ADDENDUM NUMBER 2

1.02 PROJECT: ELMORE GYM ELECTRICAL SERVICE REPLACEMENT

1.03 PROJECT NUMBER: 26239.0, DCM/BC NO. 2023098, PSCA NO. 2082

1.04 OWNER: ALABAMA A&M UNIVERSITY

| DRAWING NO. | E3.1 |

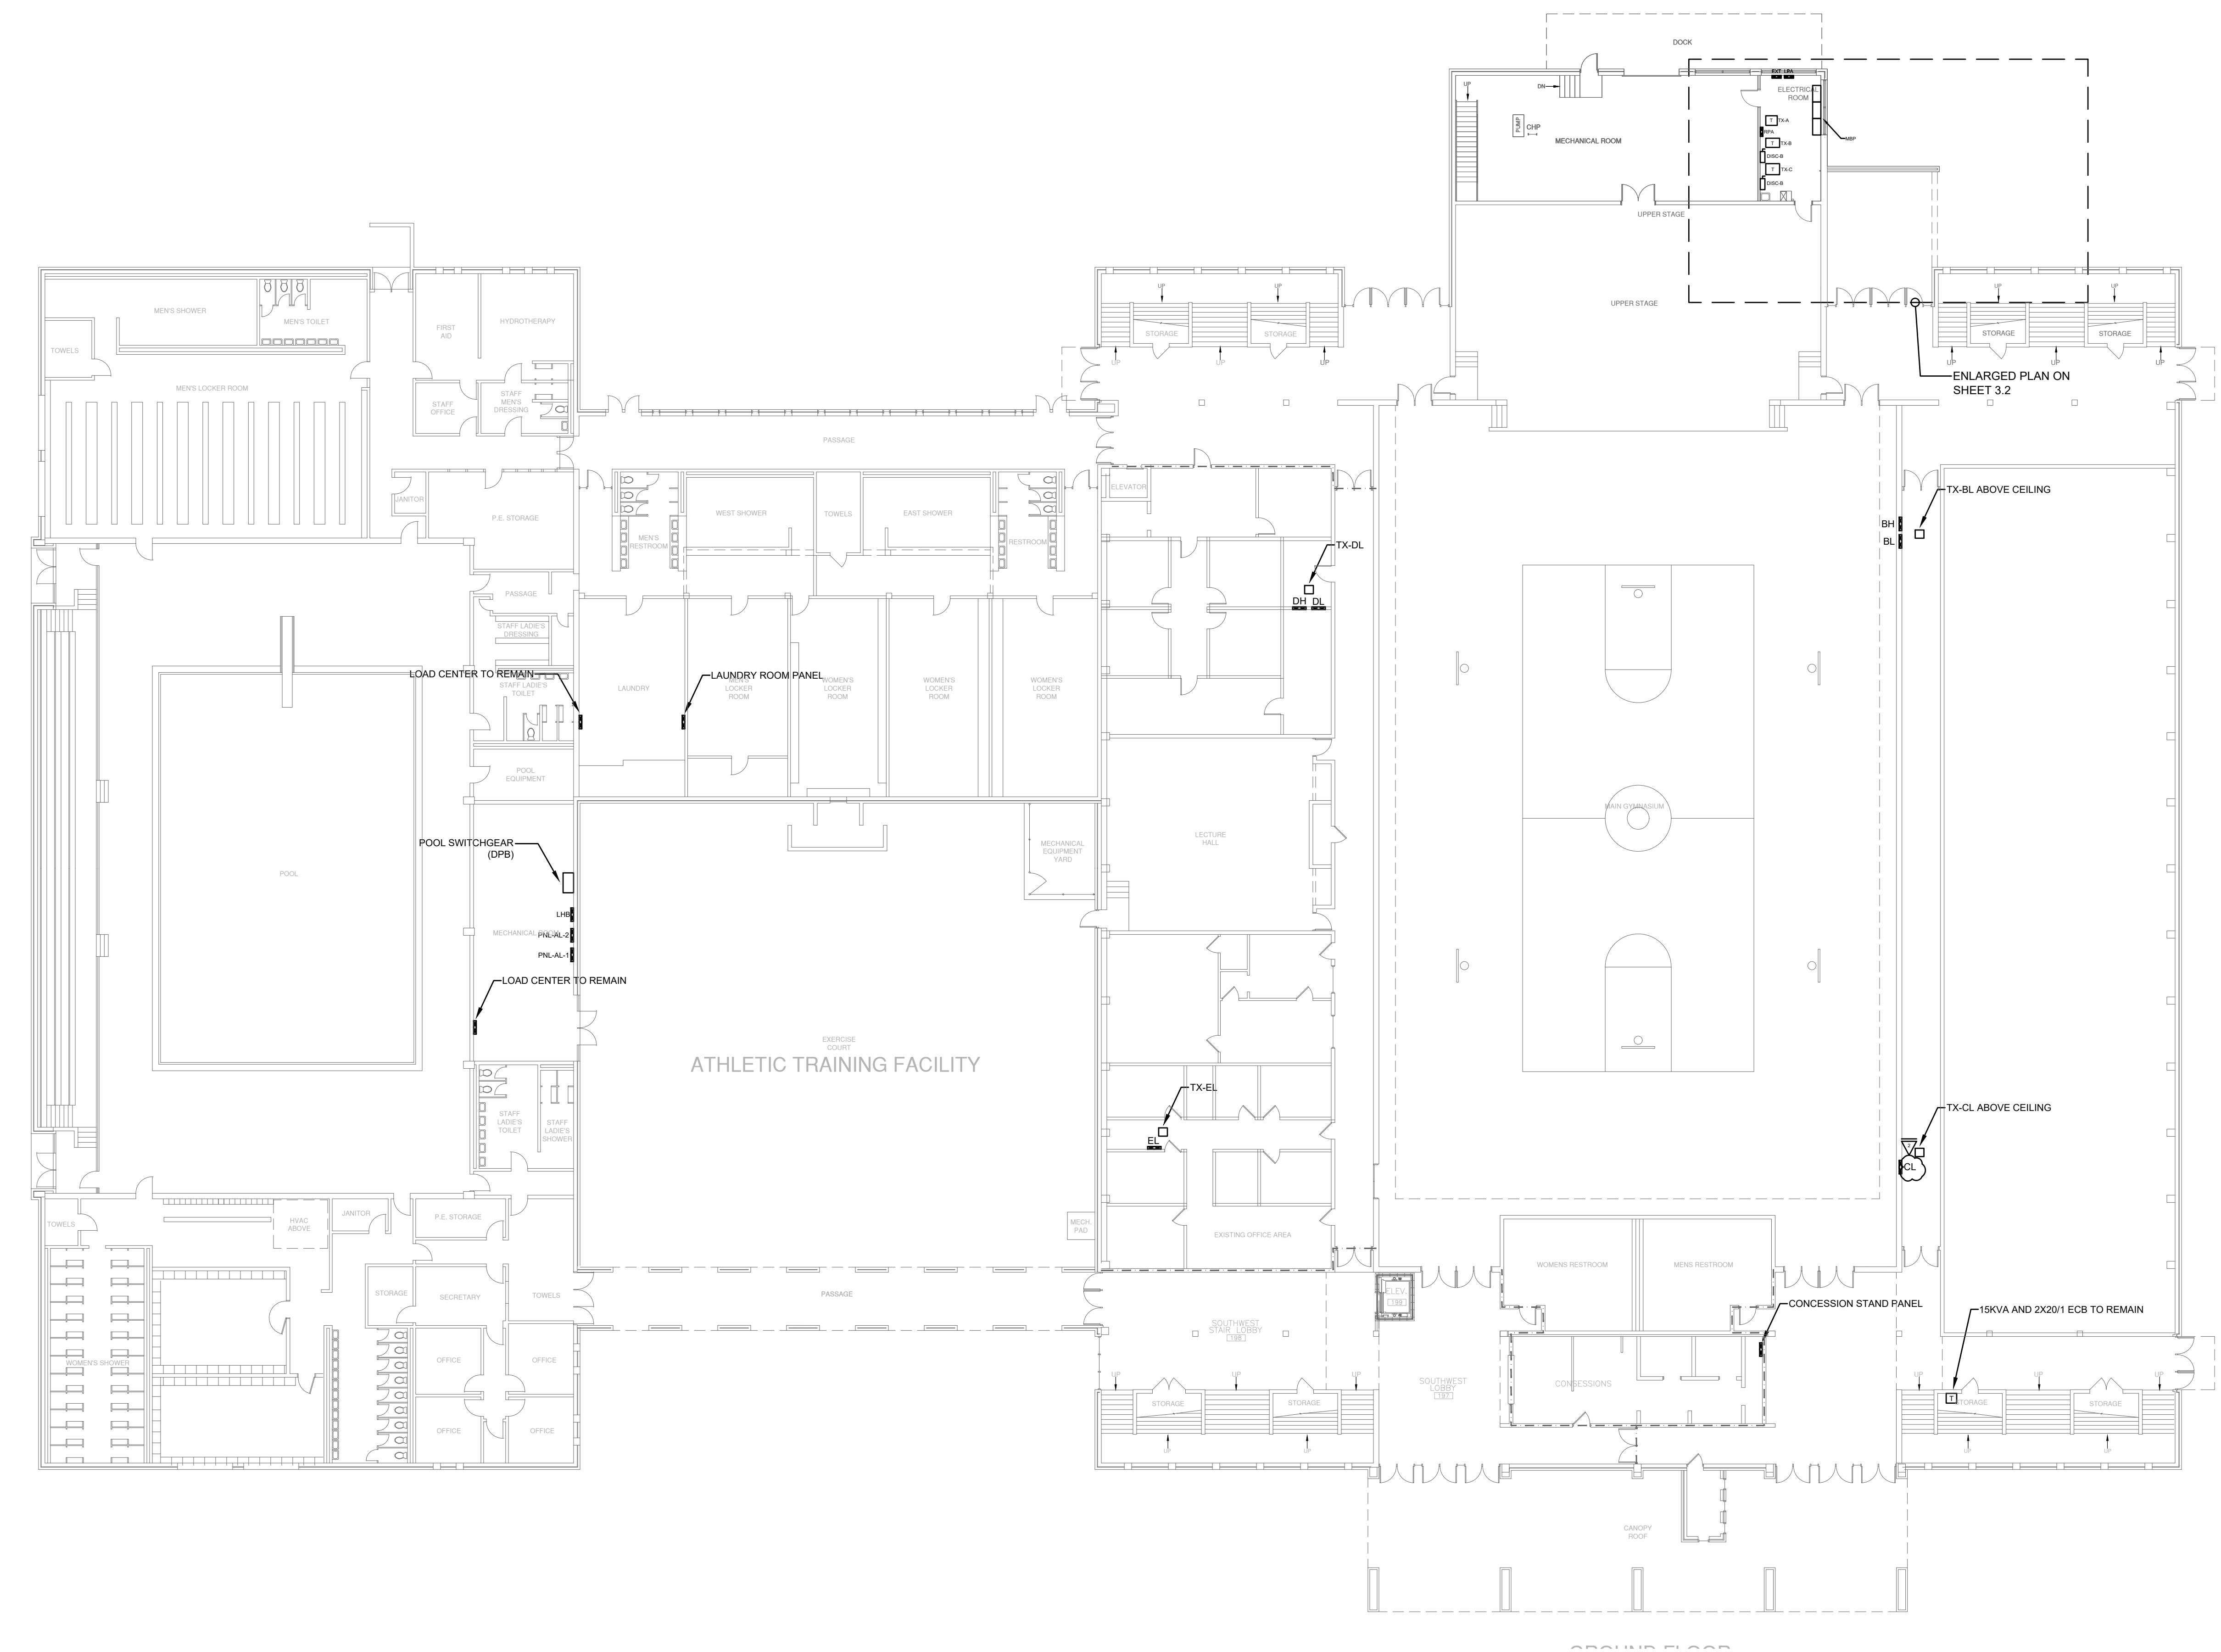
4.05 SHEET E3.1 – GROUND FLOOR PLAN - ELECTRICAL

A. Panel BL beside TX-CL has been changed to CL.
